**GOVERNMENT OF THE DISTRICT OF COLUMBIA  
DEPARTMENT OF GENERAL SERVICES**

**Buzzard Point Soccer Stadium – Site Preparation Above-Grade Structure Demolition**

**Solicitation No.: DCAM-16-CS-0031**

**Amendment No. 4**

**AERIAL SITE PLAN**  
NTS

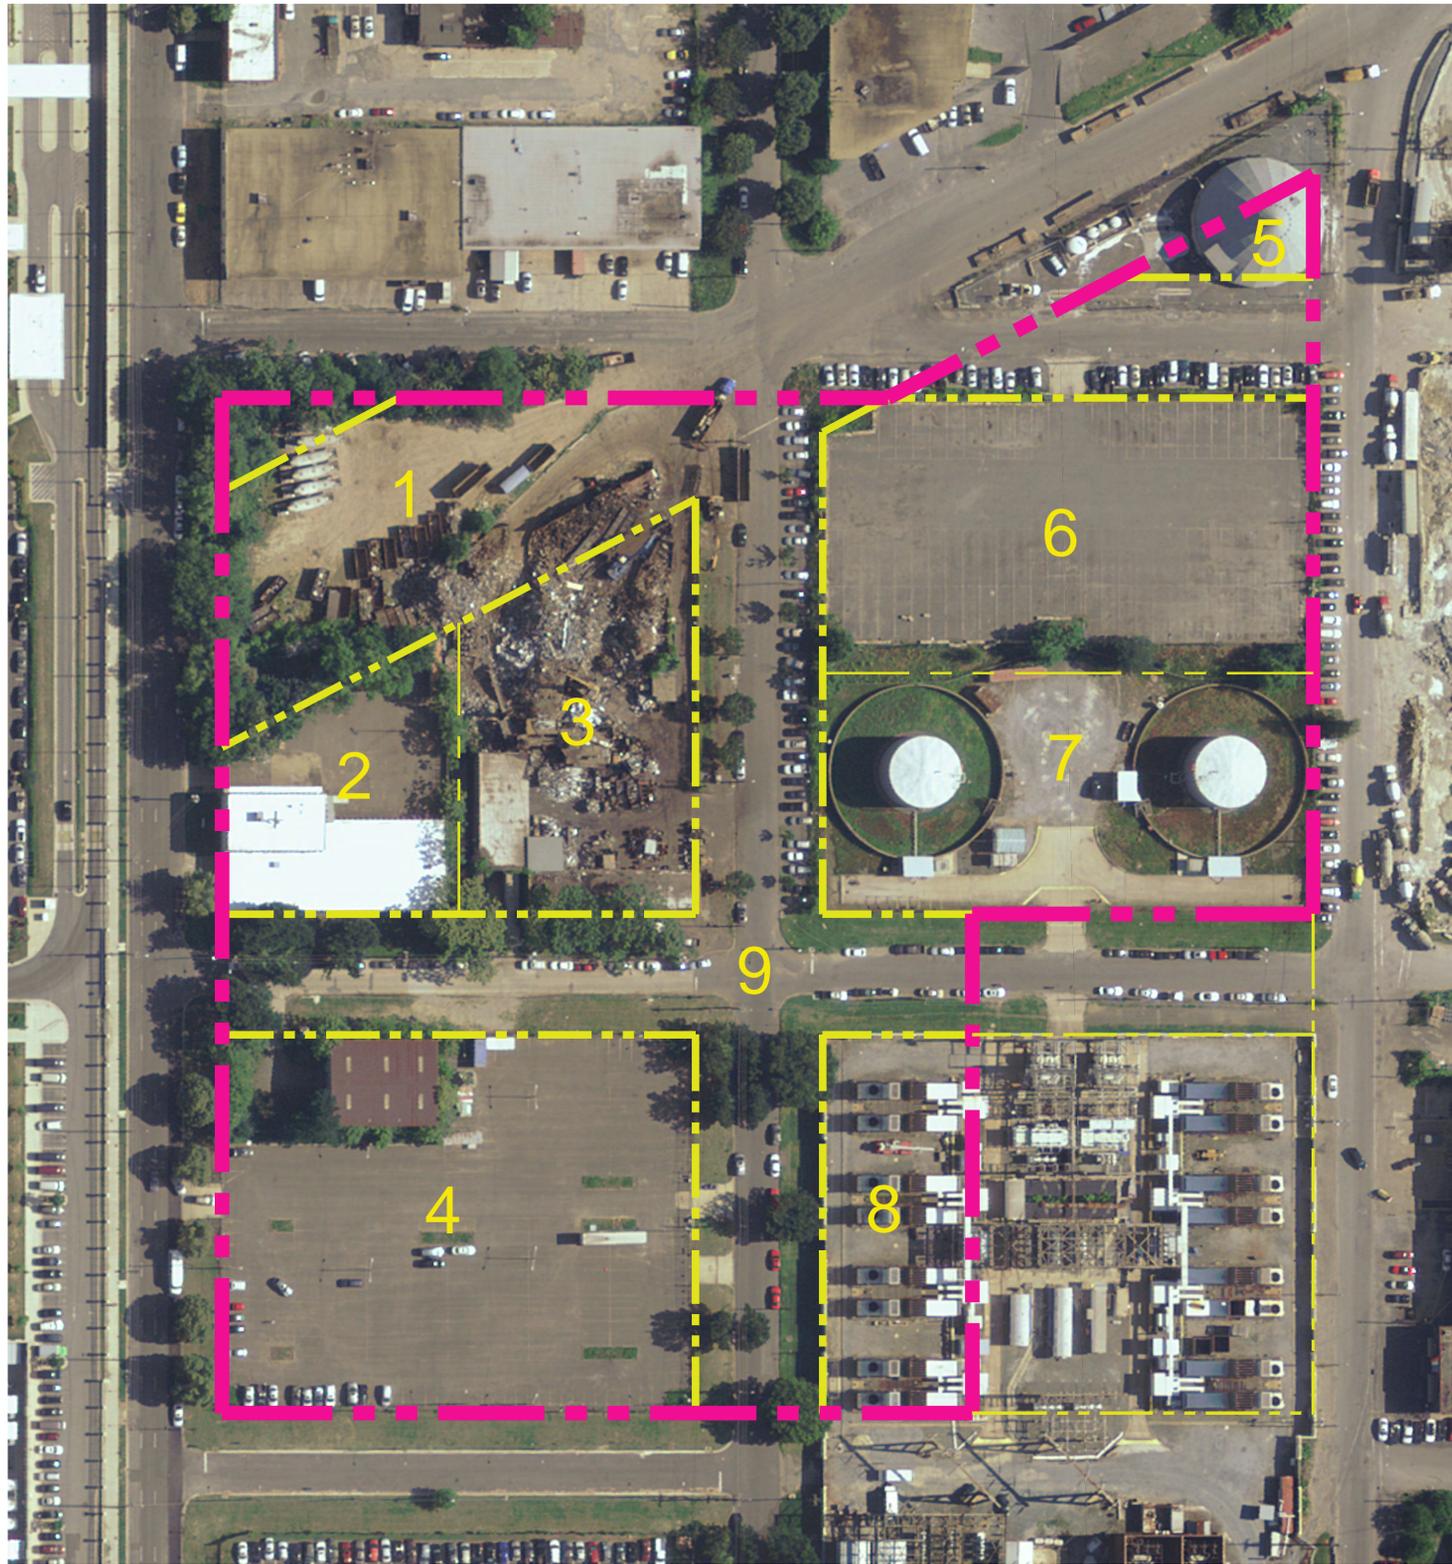
**B.2.15** – Contractor shall provide a unit price per foot to remove wall at Site 9. Contractor to assume wall is 375 feet long. An increase or decrease in cost will be issued by change order if the length of the wall increases or decreases more than five percent (5%). Wall shall be removed along with work in Site 5 on or about April 1, 2016.

- 8 PEPCO PROPERTY (SQUARE 0665 p/o LOT 0024)  
REMOVE APPROXIMATELY 375 FEET OF CONCRETE MASONRY WALL. DEMOLITION CANNOT COMMENCE UNTIL APRIL 2016 AND WITH DDOT APPROVAL. (DEMOLITION TO COINCIDE WITH THE SALT DOME DEMOLITION)  
REMOVE ANY STANDPIPES TO GRADE.
